BURLINGTON DEVELOPMENT REVIEW BOARD

Tuesday May 16, 2017, 5:00 PM

BURLINGTON DEVELOPMENT REVIEW BOARD Tuesday, May 16, 2017, 5:00 PM Contois Auditorium, City Hall, 149 Church St, Burlington, VT AGENDA

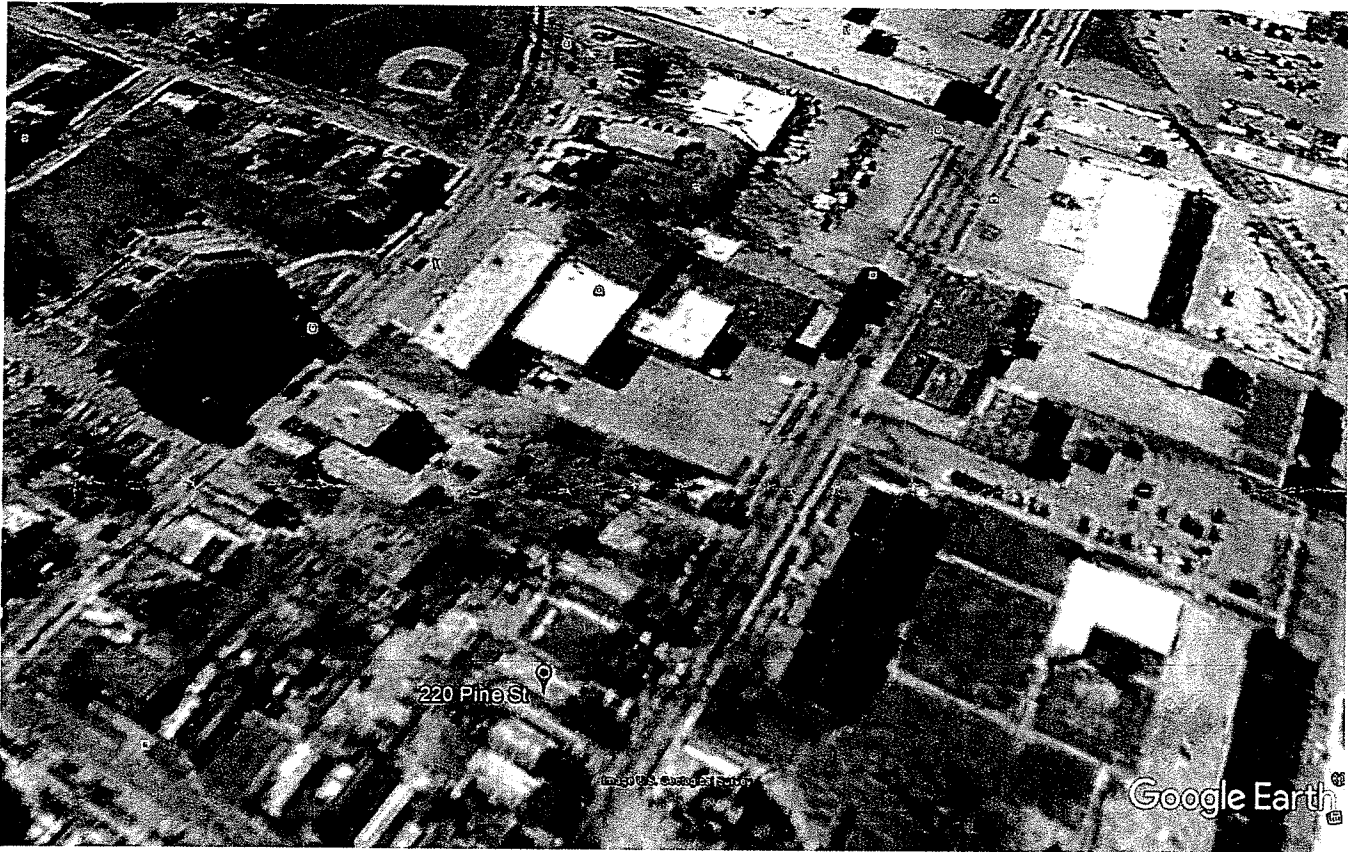
These two parking spaces are shown in the 2004 Aerial Image. Driveway has been widened.

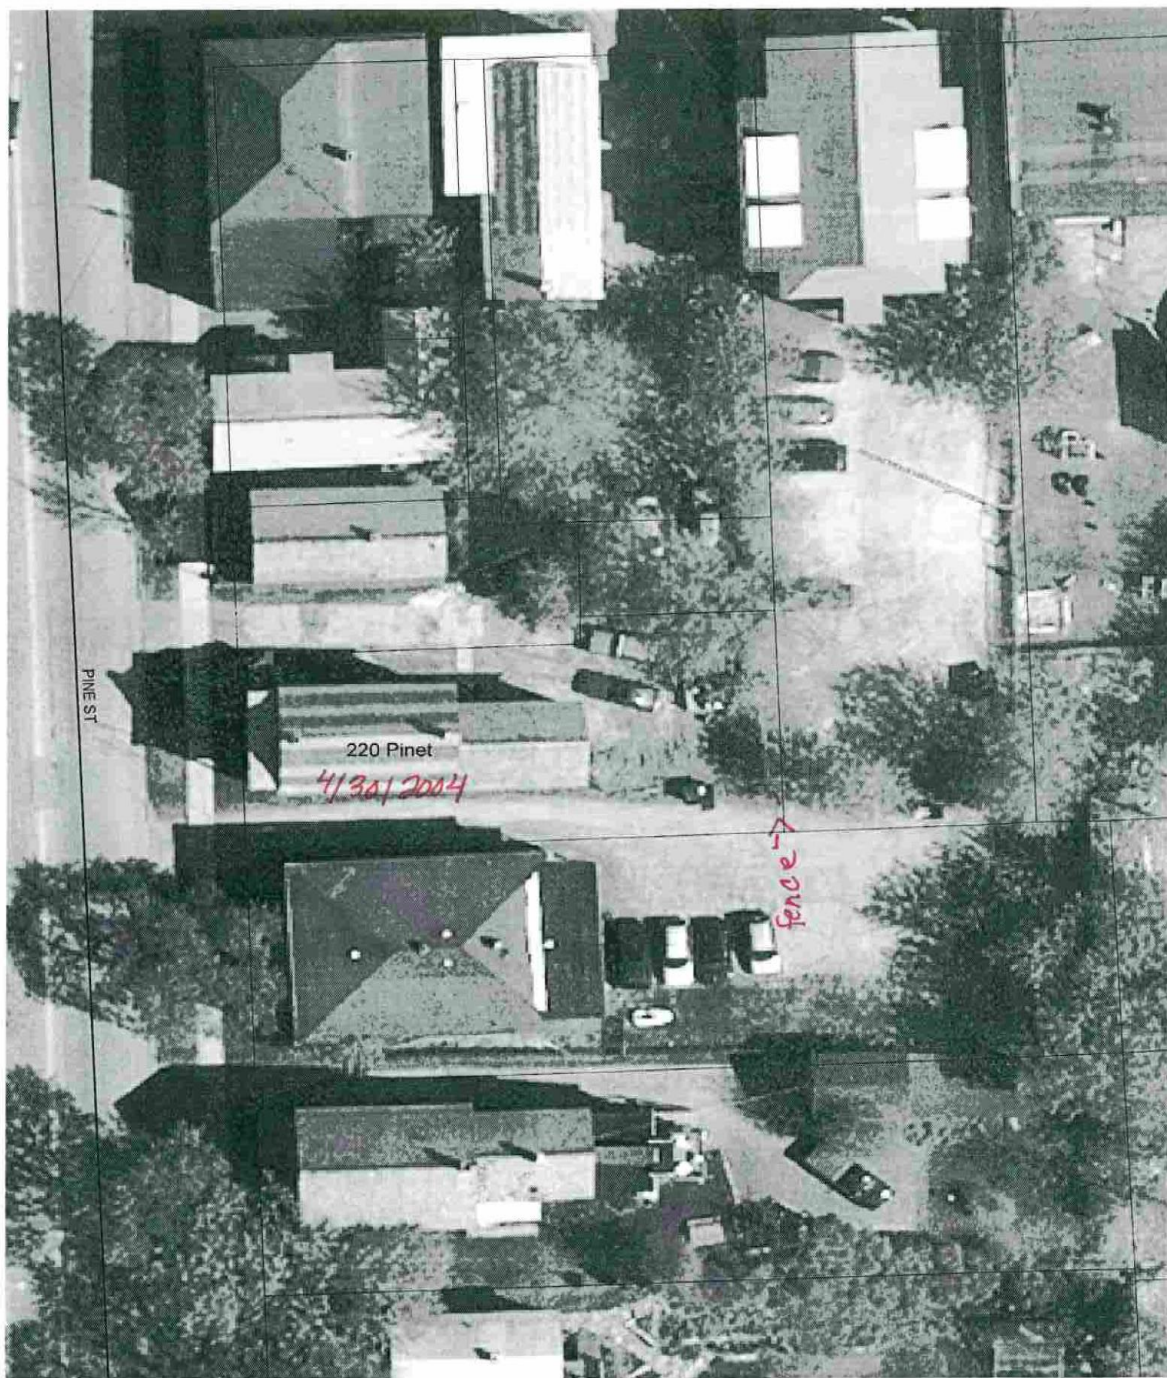
These two vehicles appear to coincide with the "Triangle" parking. Parking has expanded. The average width of a car is 9' so this appears to coincide with the 20' wide (top of) "Triangle" indicated on the 1991 site plan.

This picture is taken from Pine Street (west to east). This is the shared driveway (shared with property to the north). As you can see, the driveway has widened, vehicles have eased off the driveway and eroded grass; thus widening the driveway without permits. The two vehicles veered off the driveway appear to have veered off the “triangle” of the 1991 site plan indicating where parking was. NOTE: these trash receptacles were never shown on any site plan.
